**Re: Section 16 Planning Application for Proposed Temporary Vehicle Repair Workshop with Ancillary Facilities and Associated Filling of Land for a Period of 3 Years at Lot No. 317 in D.D. 87 and adjoining Government Land, Kong Nga Po, Sheung Shui, New Territories
(Planning Application No. A/NE-FTA/276)**

Proposed Temporary Vehicle Repair Workshop with Ancillary Facilities and Associated Filling of Land for a Period of 3 Years

Figure:	F01
Scale:	1:400 @ A4
Drawing Date:	Jun 2026

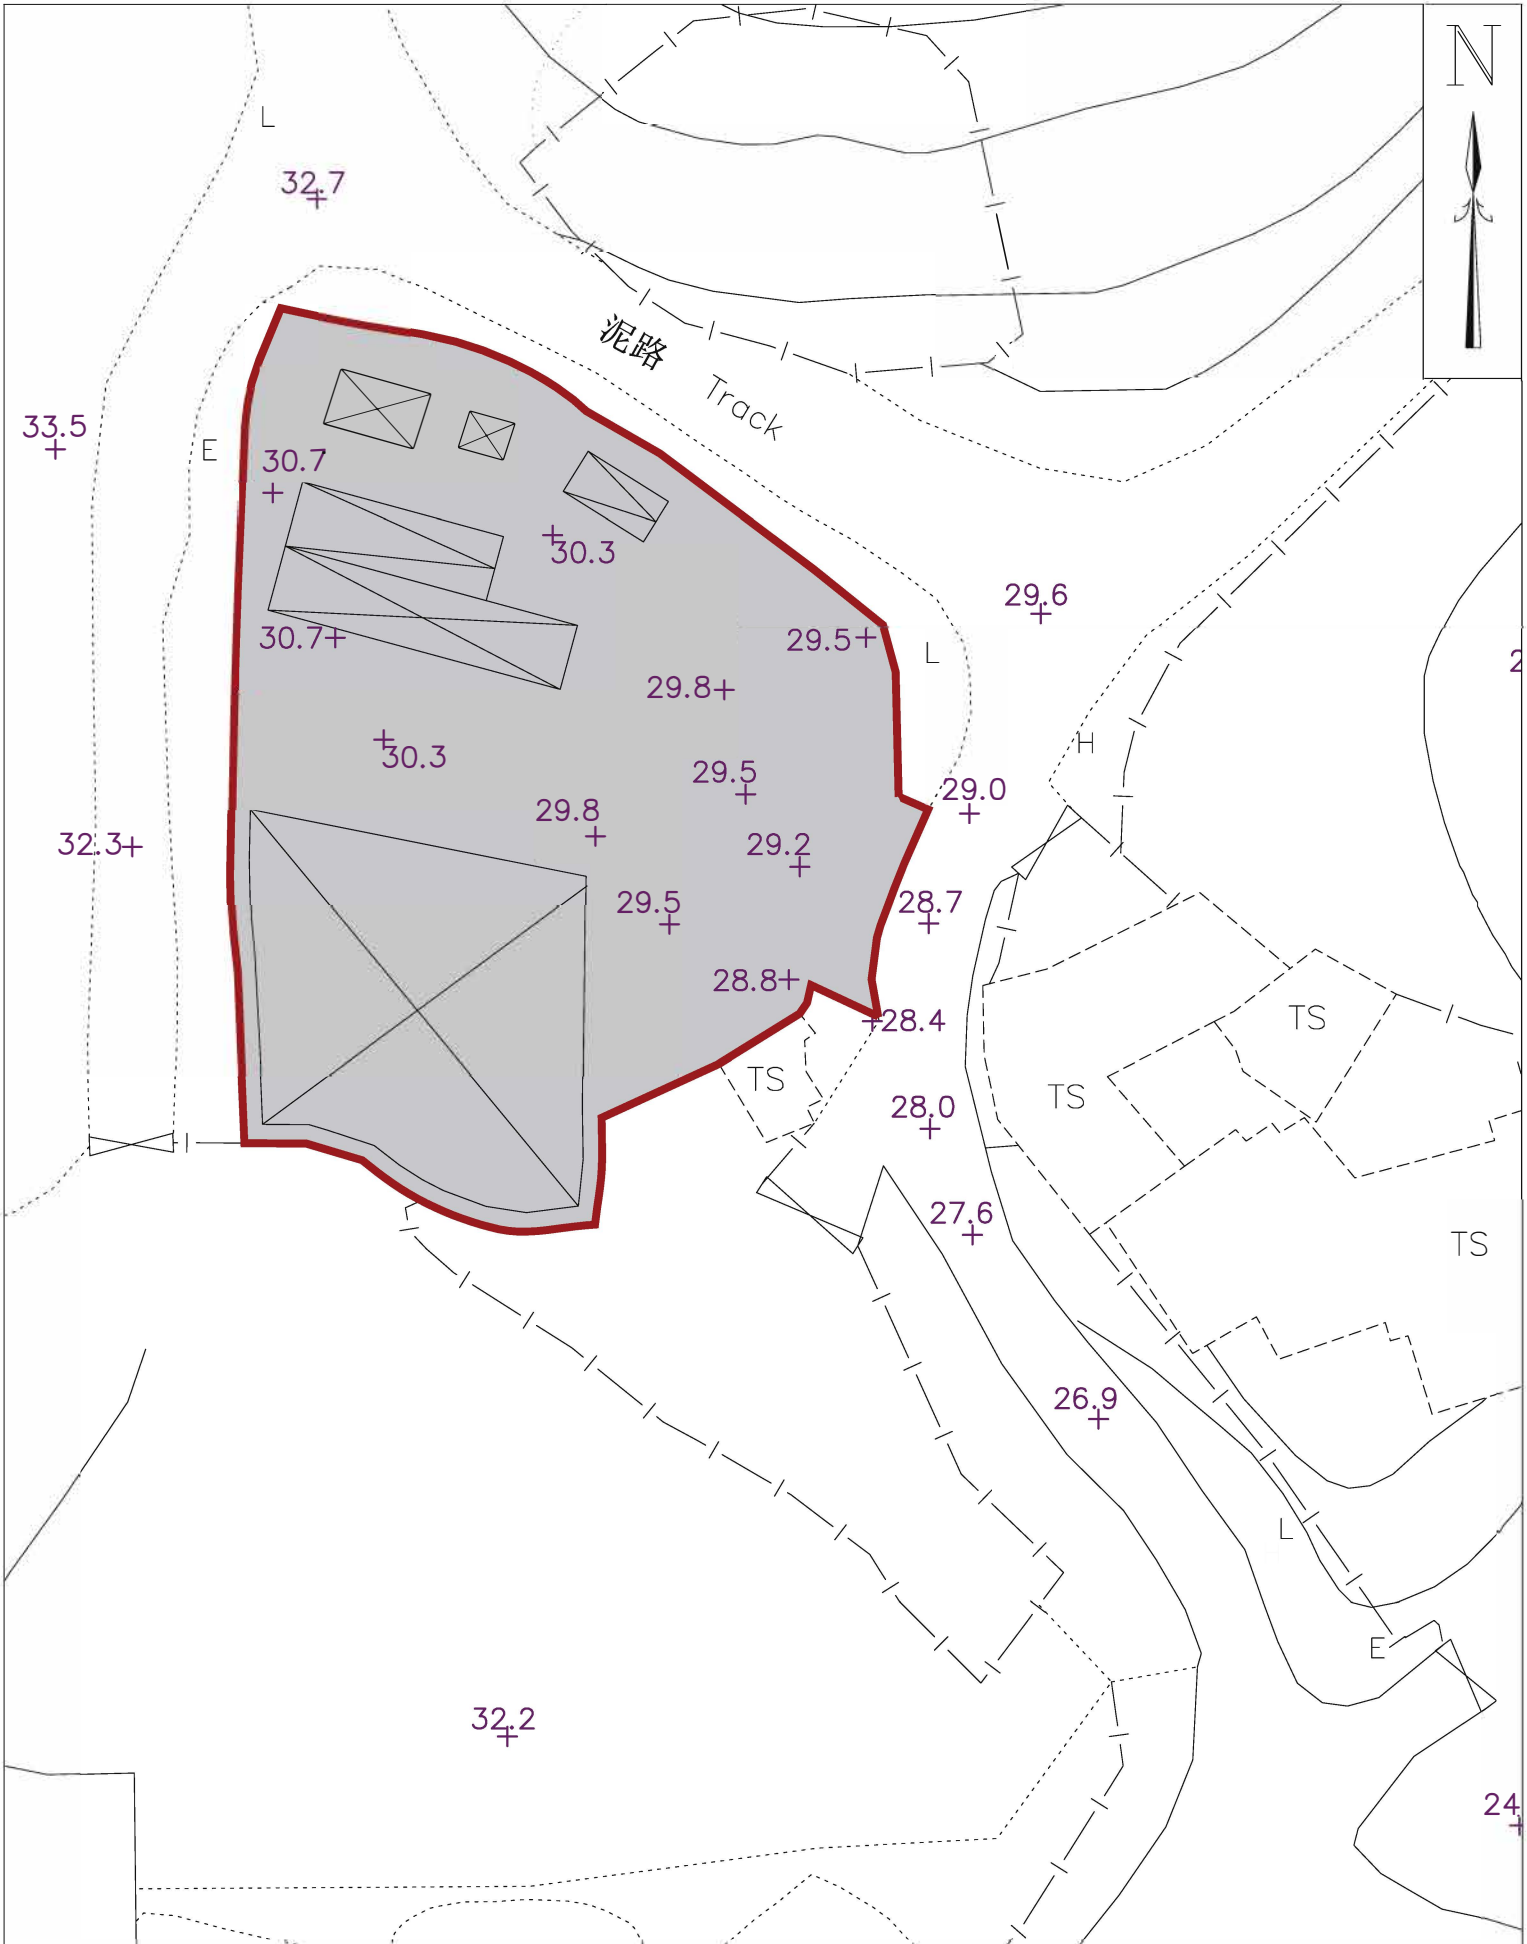
Department	Date	Comments	Responses to Departmental Comments
Transport Department	16.6.2026	The applicant should provide the land filling plan demonstrating that the vehicles can maneuver within the applicant site (the Site) and enter/exit the Site freely, preferably by using a contour plan.	Refer to Figure F01 . The proposed contour points demonstrate that the site gradient is suitable for heavy vehicle movement, with no risk of grounding or instability. In addition, the previously provided swept path analysis confirms that vehicles can maneuver within the application site and enter/exit the application site freely.
